Montgomery County Historic Preservation

Staff Report

<p>ADDRESS: 7818 Overhill Rd., Bethesda</p> <p>RESOURCE: Greenwich Forest Historic District</p> <p>APPLICANT: Bill and Allison Trunk</p> <p>REVIEW: HAWP</p> <p>CASE NO.: 1155067</p> <p>PROPOSAL: Accessory Structure Alterations</p>	<p>MEETING DATE: 5/13/2026</p> <p>REPORT DATE: 5/6/2026</p> <p>PUBLIC NOTICE: 4/29/2026</p> <p>TAX CREDIT ELIGIBLE: No</p> <p>STAFF: Dan Bruechert</p>
--	---

TRUNK GARAGE RENOVATION

1 PROPOSED GARAGE PLAN - LOWER LEVEL
Scale: 1/4" = 1'-0"

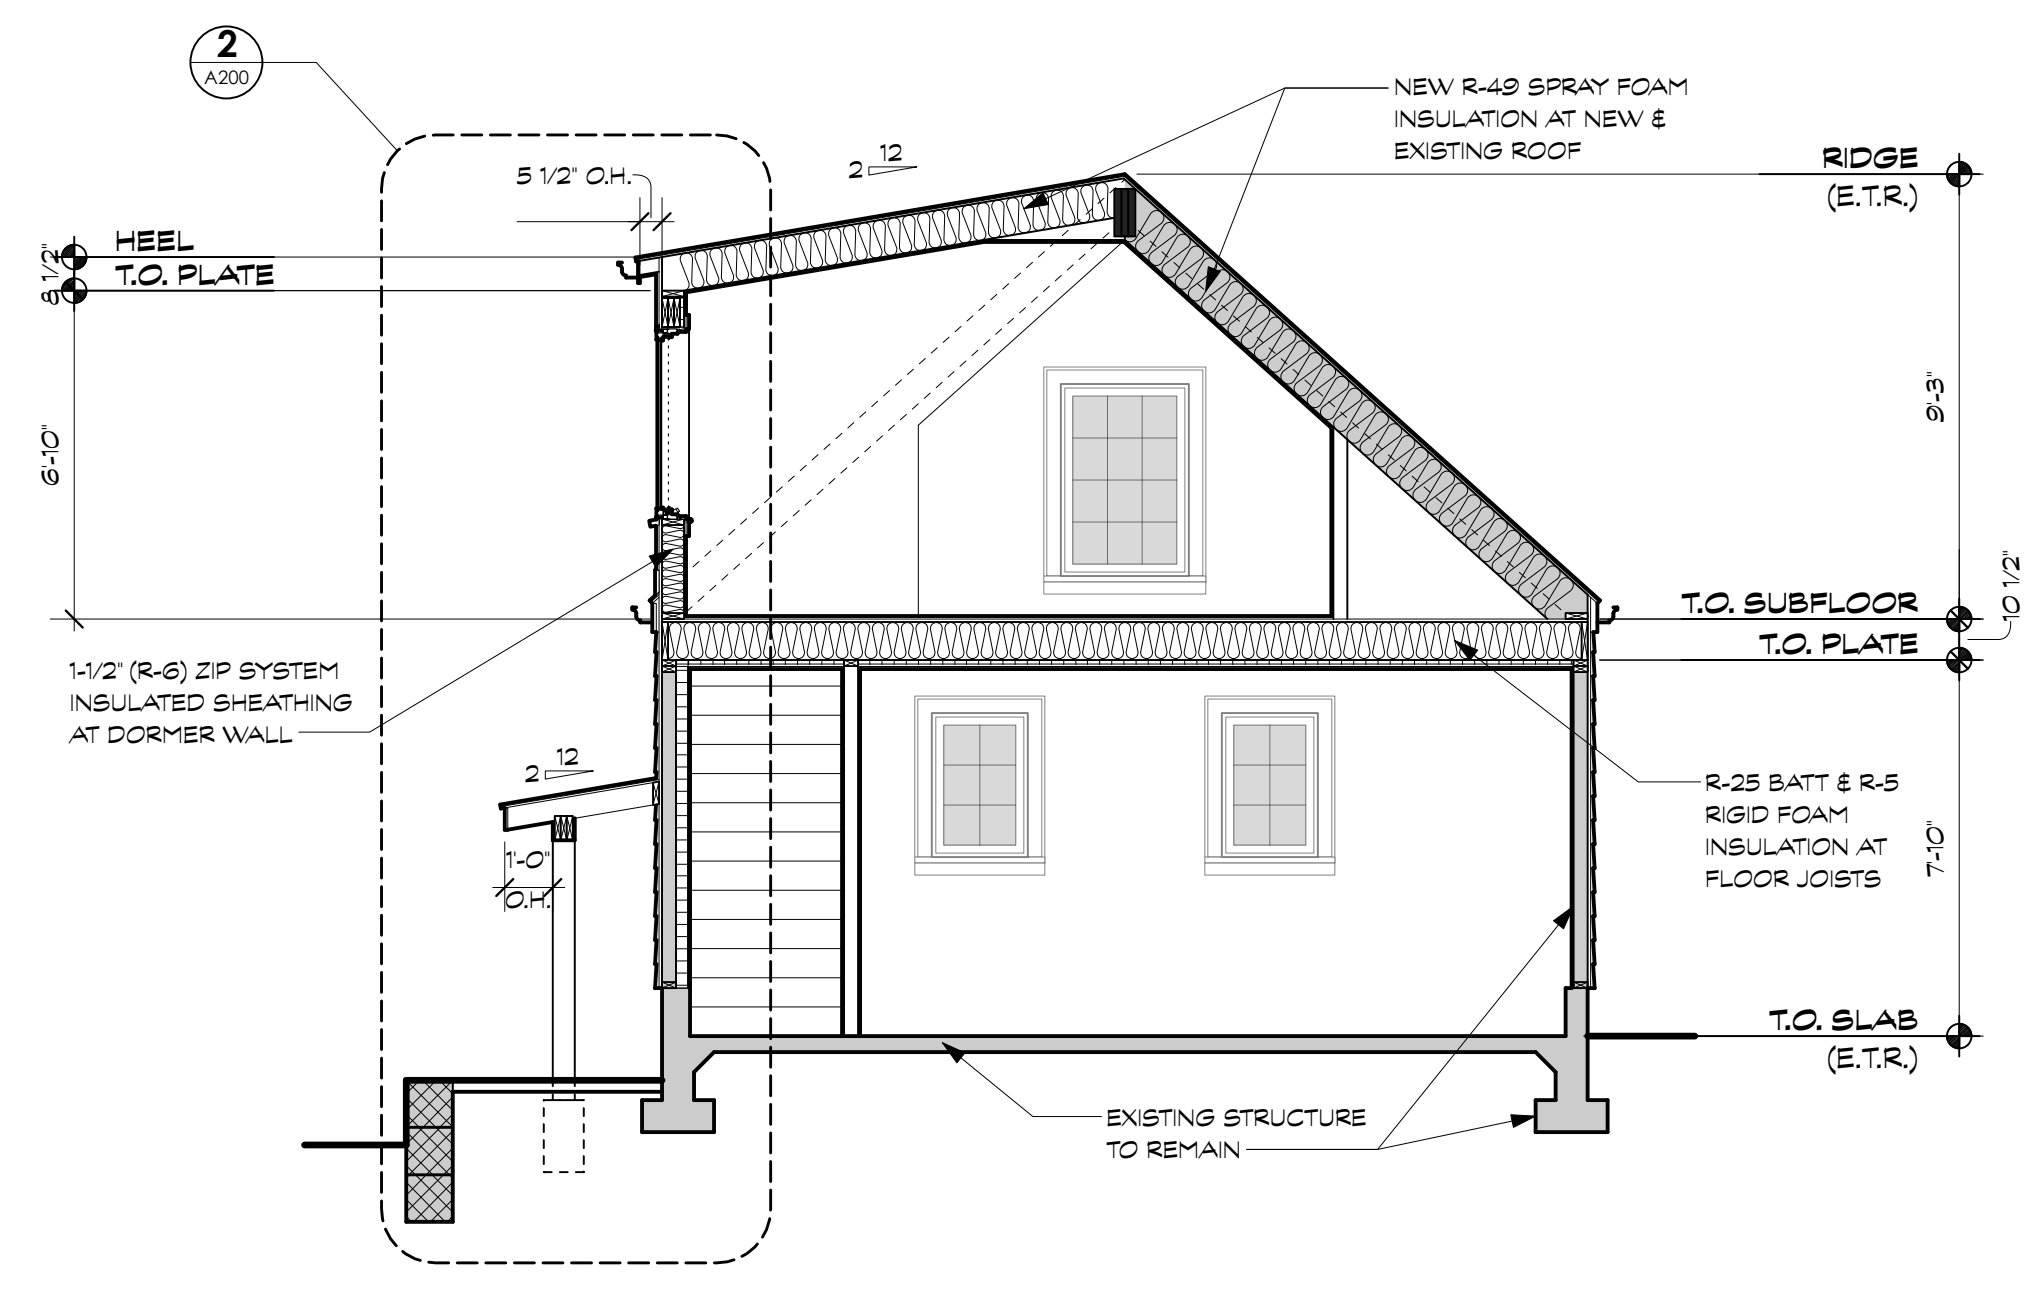
The applicant proposes to construct a shed dormer on the left (south) roof slope of the garage. The dormer will be 13’ 5 ½” (thirteen feet, five and one-half inches) wide and is set back 4’ (four feet) from the front wall plane. The dormer’s roof slope is a low 2:12 and will have a metal roof. Siding and trim details on the front and rear elevations will match the new siding and trim, discussed above. On the left elevation, the applicant proposes to install fiber cement panel siding and four twelve-lite Weathershield Signature Series aluminum clad casement windows.

Staff finds the dormer will alter the massing of the garage, but will retain the outline of the original building, an identified objective of guideline D4; and does not raise the roof ridgeline as required in D17. Additionally, Staff finds the siding is identical to the fiber cement siding proposed to replace the deteriorated wood siding (discussed above), which will aid in making the design more cohesive. Finally, Staff finds the dormer’s proposed aluminum clad windows are appropriate for new window openings in the Greenwich Forest Historic District, as outlined in D17, as they have a traditional grille pattern and provide sufficient dimensional details to approximate the appearance of a wood window.

Staff finds the existing garage door may be the historic configuration, as the only access to the garage interior is through this door. The door appears to suffer from some deterioration, particularly where the door meets the driveway. The *Design Guidelines* provide a very lenient requirement for replacing windows and doors and do not require that they have deteriorated beyond repair as is the case in most of the county's historic districts. The primary consideration is that the windows and doors are consistent with the design of the house and that windows have permanently affixed exterior divisions. Staff finds the proposed replacement swing door satisfies these criteria. The front elevation of the proposed garage shows a replacement overhead door with vertically oriented boards, but no material or detailed specifications were included in the application materials. Staff recommends the HPC add a condition to the approval of this HAWP that requires detailed overhead door specifications be submitted to Staff before issuing the final HAWP approval documents. Final approval authority to ensure the door design and materials are appropriate under D17 can be delegated to Staff. With the recommended condition, Staff finds the proposed door replacements are consistent with the *Design Guidelines*, 24A-8(d), and *Standard #2*.

The garage has four window openings. There are a pair of wood casement windows under the gable on the front elevation. On the rear there are two wood six-lite casement windows on the ground floor and a paired set of casement windows under the gable. All of the windows appear to be historic. The applicant proposes to replace the existing windows with Weathershield Signature Series aluminum clad windows in matching dimensions and configurations.

Staff finds the proposed shed will not have a substantial impact on the character of the garage. Its simple, open design does not detract from the historic form of the garage. Staff additionally finds the proposed materials are compatible with the character of the garage. The metal roof matches the dormer roof and the wood framing and posts are traditional materials. A specification for the stone pavers was not provided and Staff recommends the HPC include a condition to the approval of this HAWP to require the applicant to submit a detailed specification for the pavers to Staff for review and approval before issuing the final approval documents. Final approval authority to ensure the material is appropriate can be delegated to Staff. With the recommended condition, Staff finds the shed roof construction is compatible with the character of the garage and the *Design Guidelines*, 24A-8(b)(2) and (d), and *Standard #2*.

Staff recommends the HPC approve with two (2) conditions the HAWP application with final approval delegated to staff:

1. A detailed specification for the overhead garage door must be submitted before issuing the final HAWP approval documents.
2. A detailed specification for the pavers under the shed roof must be submitted before issuing the final HAWP approval documents.
